**CITY OF MADISON
INTERDEPARTMENTAL
CORRESPONDENCE**

To: Plan Commission
From: Matt Tucker, Zoning Administrator
Subject: 666 Wisconsin Avenue

Proposed Use: Renovate existing hotel, modify existing hotel, and construct an 8 story hotel addition.
Waterfront Development Conditional Use.

MAJOR OR NON-STANDARD REVIEW COMMENTS (Comments which are special to the project and/or may require additional work beyond a standard, more routine project).

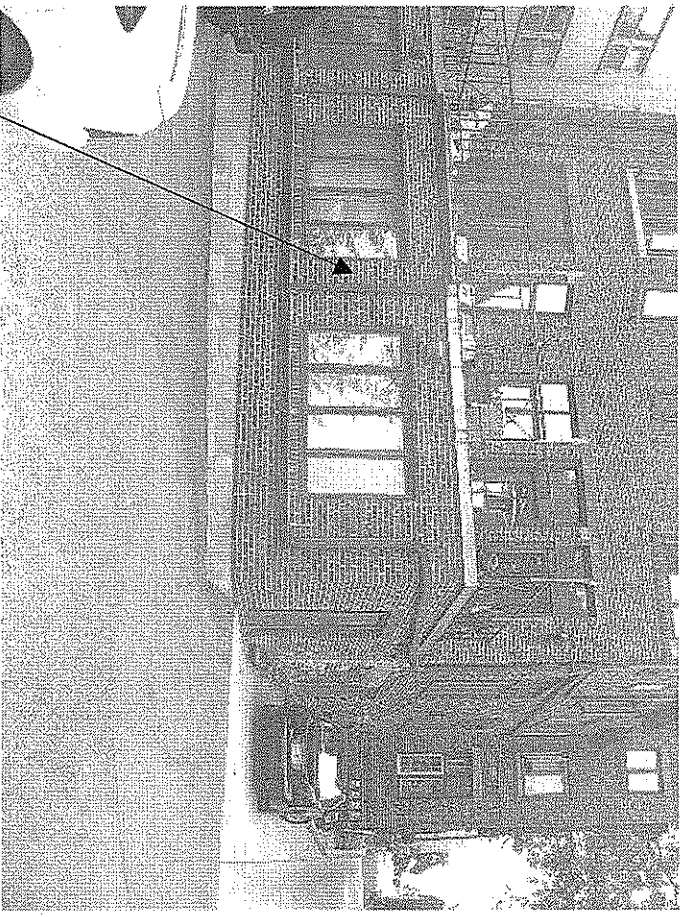
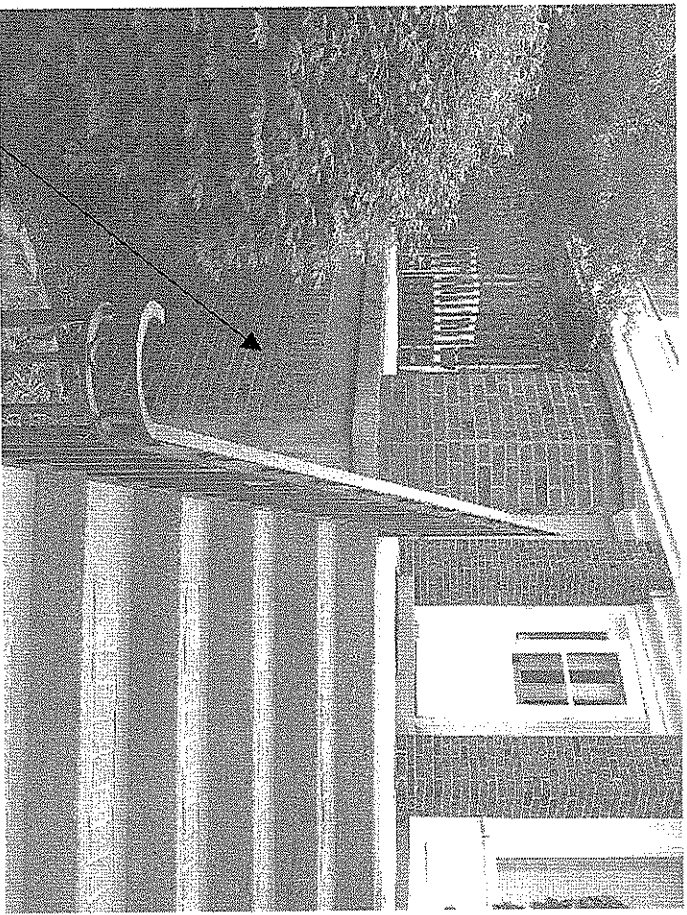
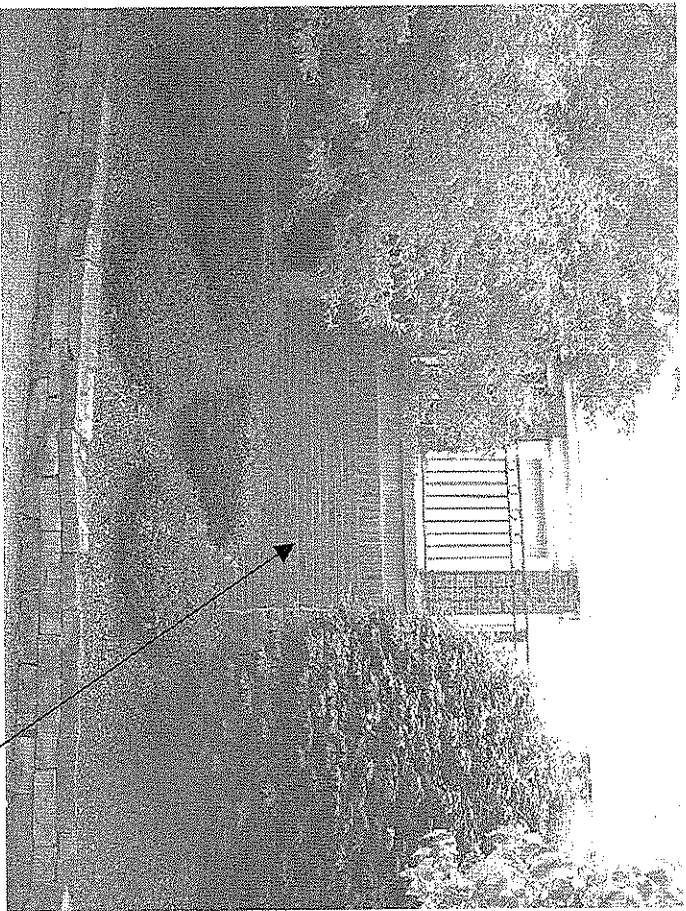
1. When we met previously to discuss this issue, there was some question as to what portion of the buildings you should measure to for 12 and 28 Langdon Street. I recall that your group wanted to measure to a retaining wall for a surface parking lot at 12 Langdon St., and also wanted to measure to an at-grade patio for 28 Langdon St. I had indicated at that time that you could not measure to those features, you needed to measure to the buildings and other qualifying portions of the buildings (please see the attached pictures specifically showing where to measure to). In looking at the aerial photo accompanying the submittal, it looks like you measured to the parking lot and surface patio, and not the qualifying portions of the buildings. I see in your submittal, beneath Table 1, you provide a general statement describing the measurement. For clarification purposes, would you please identify where you measured to for 12 and 28 Langdon Street, or a survey showing the features you have measured to?

Measure to this wall of bldg

Measure to the edge of this elevated patio

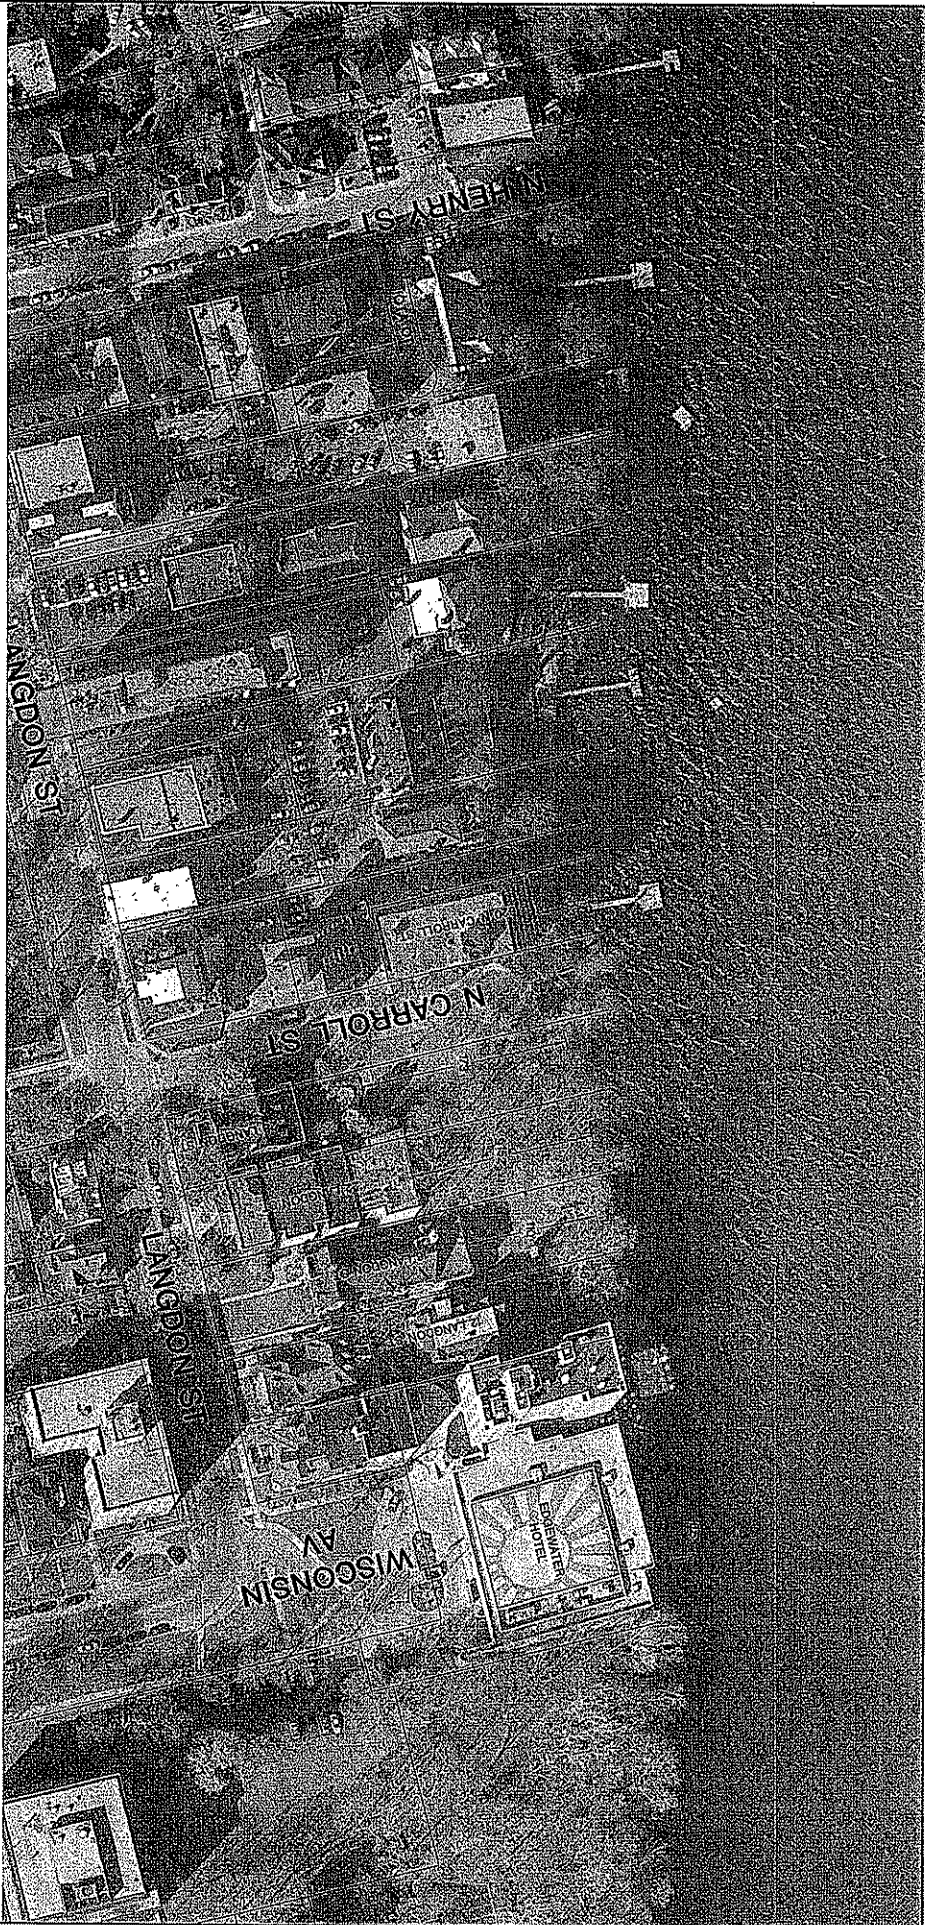
2. The City's maps and your submittal show the development at 116 E. Gilman having a narrow corridor out to the lake. I recall asking you to research this property, specifically to check if the legal description of the property (as on-file in the Dane County Register of Deeds office) indeed represents what is shown on yours and our maps. If this is true, thus property qualifies as one in the "existing development pattern" average, and site at 150 E. Gilman St. (the Verex Plaza office building) would be dropped. Please confirm.

2. The Vilas mansion/NGL boathouse is not a principal structure, it is an accessory structure. Per my review of the Waterfront Development section of the code, the setback is established by principal buildings on developed zoning lots, not accessory buildings/structures. So, the counting of the boathouse with a setback measurement of 0' is not consistent with the measurement calculation. You will need to provide the setback of the NGL building, as this is the principal building on the zoning lot where the boathouse sits.
